Service note

ACS 1000 auxiliary power upgrade

Auxiliary power upgrade

Old power supply concept

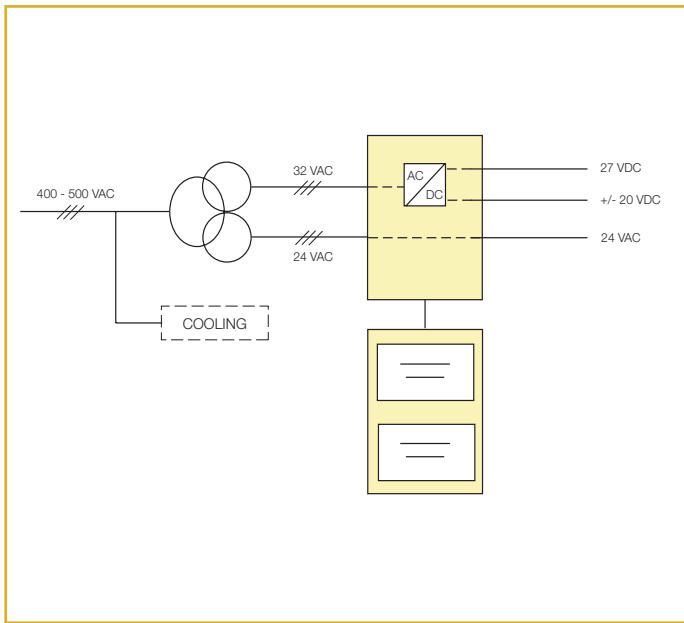
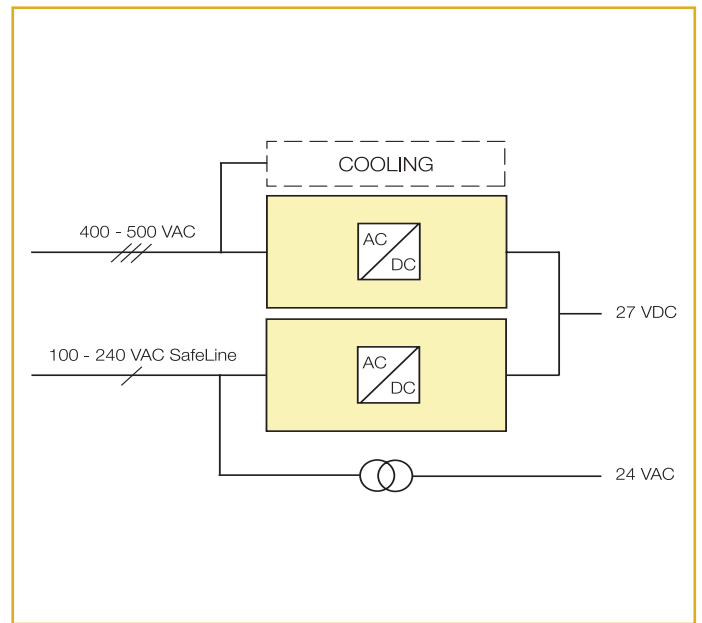
The probability of malfunction of electrical equipment does not only depend on the reliability of the equipment itself, but also on external factors, such as network conditions. In case of an auxiliary power loss, the ACS 1000 can cope with a power loss as the drive is equipped with backup batteries. These batteries limit the "Power-Loss-Ride-Through" to one second. However, batteries have a limited life expectancy.

To overcome these constraints, a new auxiliary power concept without backup batteries has been designed and is now available as a retrofit option.

In addition to the standard three phase auxiliary supply which is used also for cooling. The new power supply concept uses a safe line auxiliary source from the customer's UPS to supply the drive power supplies. This upgrade further improves the reliability and availability of the ACS 1000.

New power supply concept
